VICTA

SERVICE BULLETIN

No. 61
D.C.A. APPROVED

SUBJECT: Auxiliary Trim Bungee

SERVICE BULLETIN NO. 43

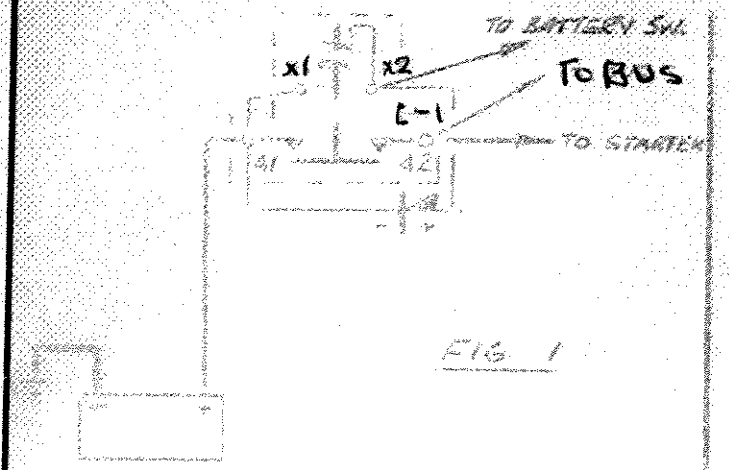
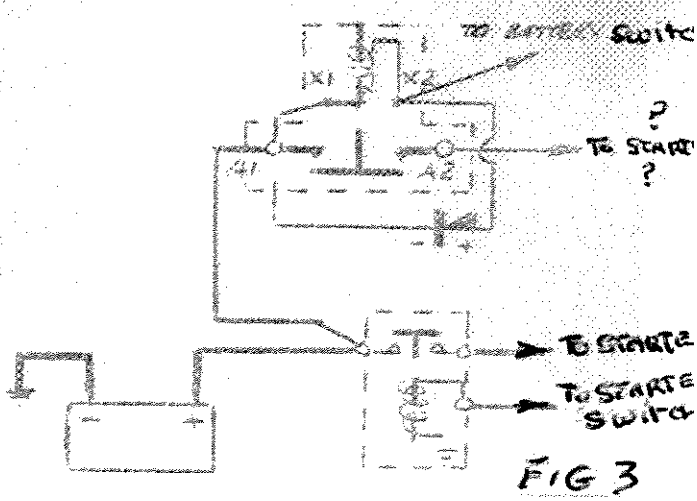
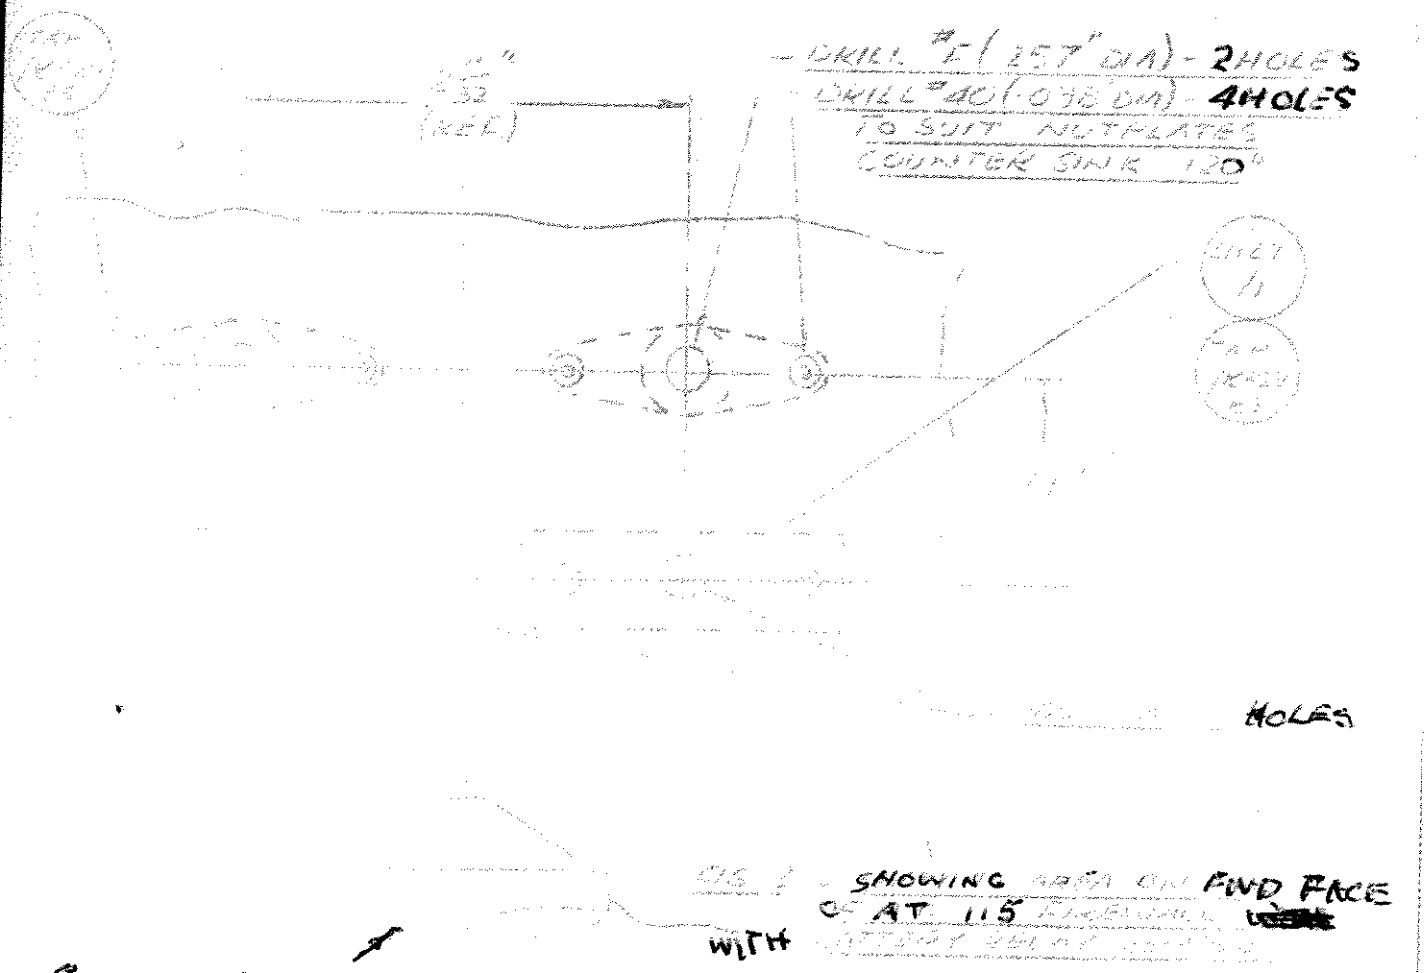
STARTER RELAY

SERVICE BULLETIN NO. 43

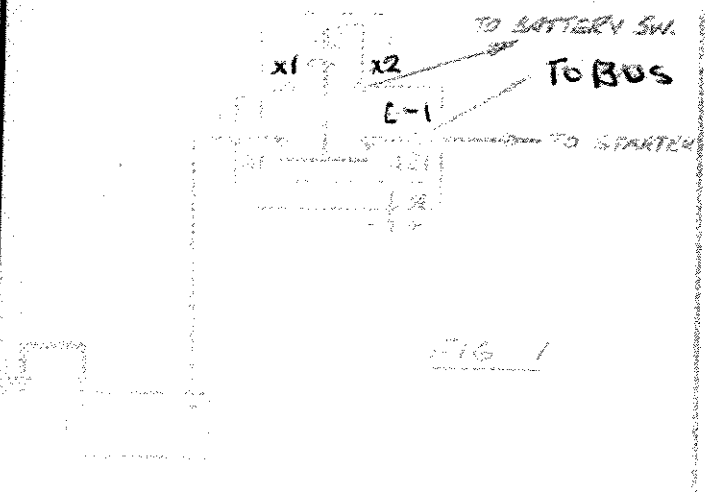
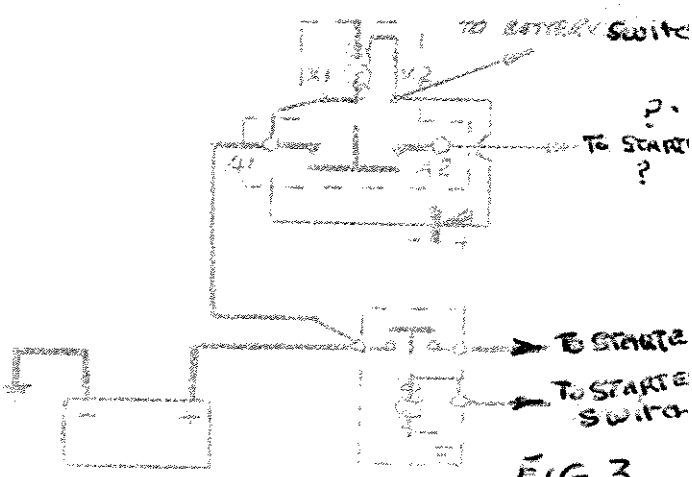
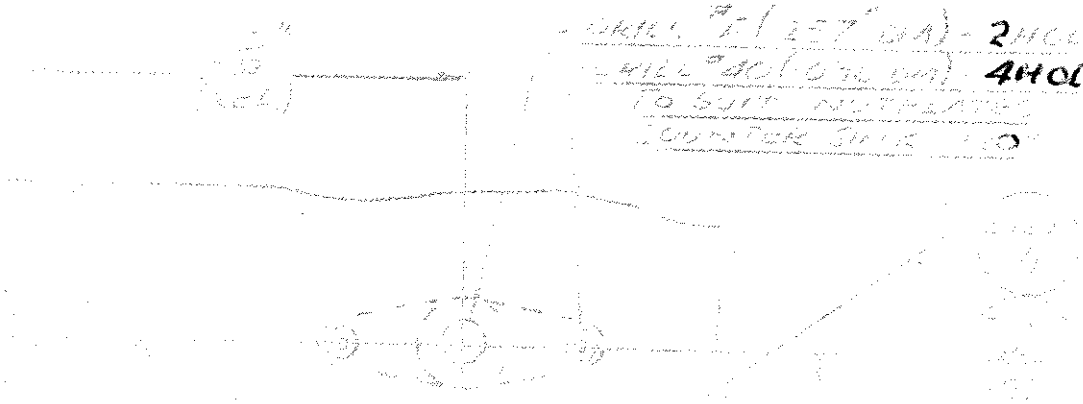
SHOWING
AT 115
WITH
FWD FACE

SERVICE BULLETIN No. 61

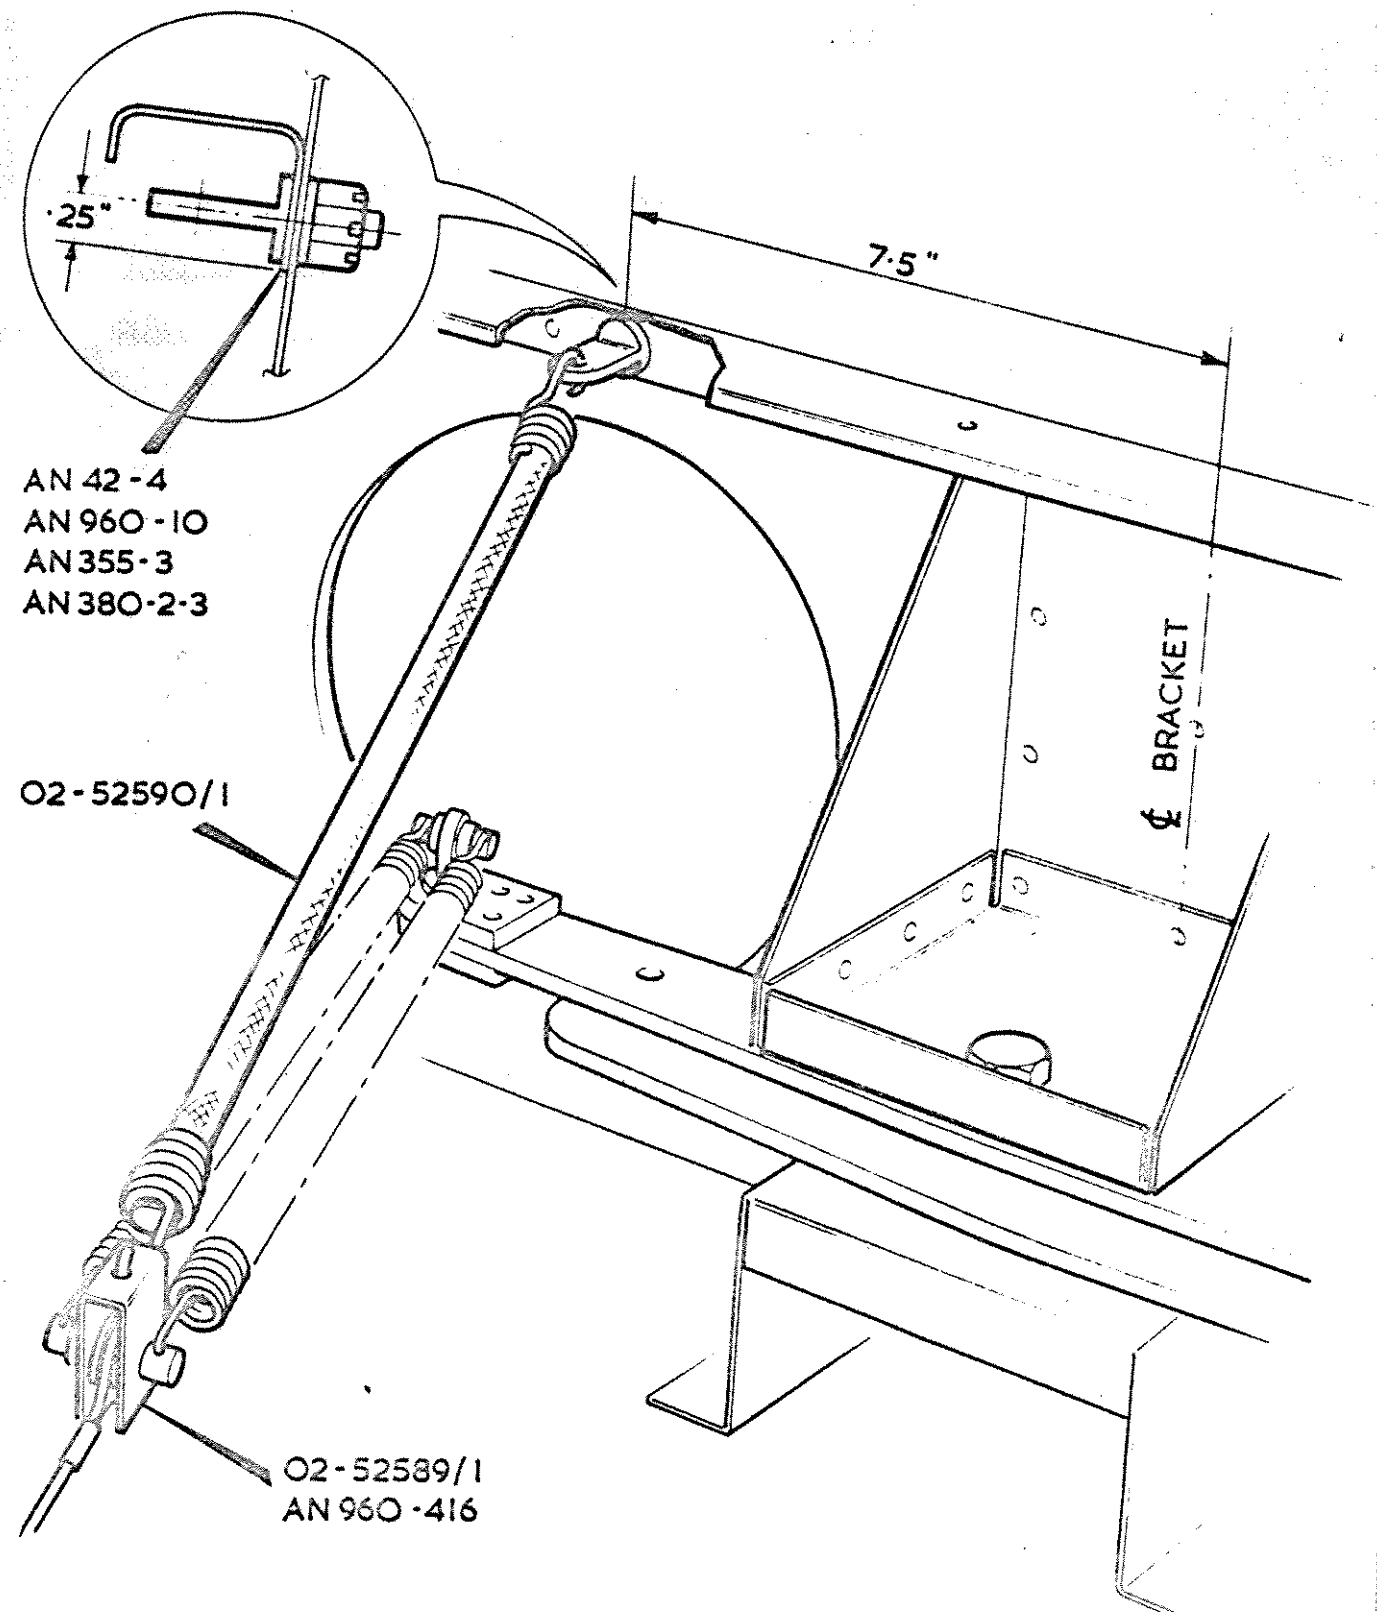
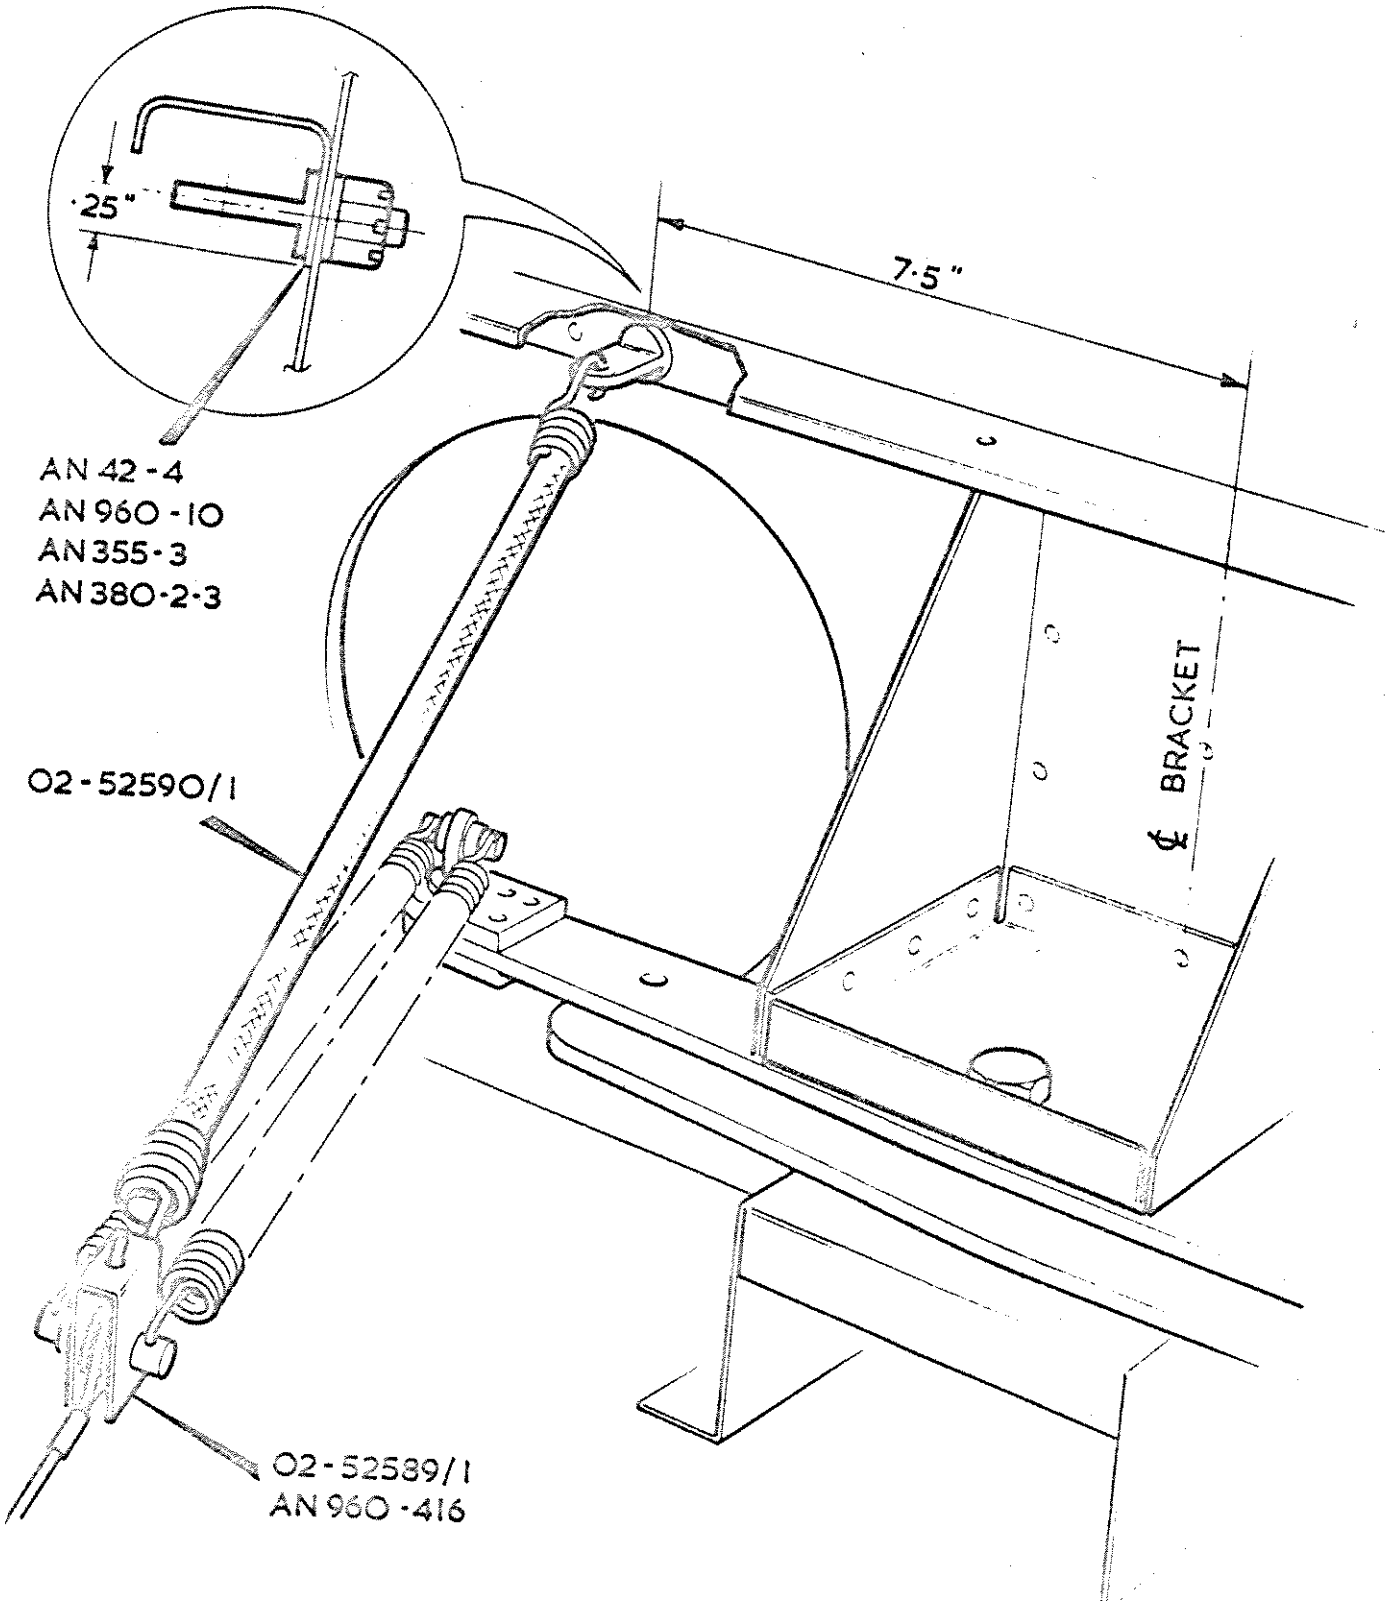
REASON: The Airtourer 115 trim lever has been heavy to adjust to the full nose up postion. Several cases have been reported of the trim becoming disengaged due to the heavy load and moving to the nose down position.

(1) Remove luggage bay floor

(2) Drill No. 11 through rear member as shown on page 3 and install eyebolt Part No. AN 42-4.

(3) Disconnect forward end of nose-down spring and install shackle Part No. 02-52589/1 using AN960-416 washers as spacers inside shackle.

(4) Re-connect spring and install auxiliary bungee. Part No. 02-52590/1.
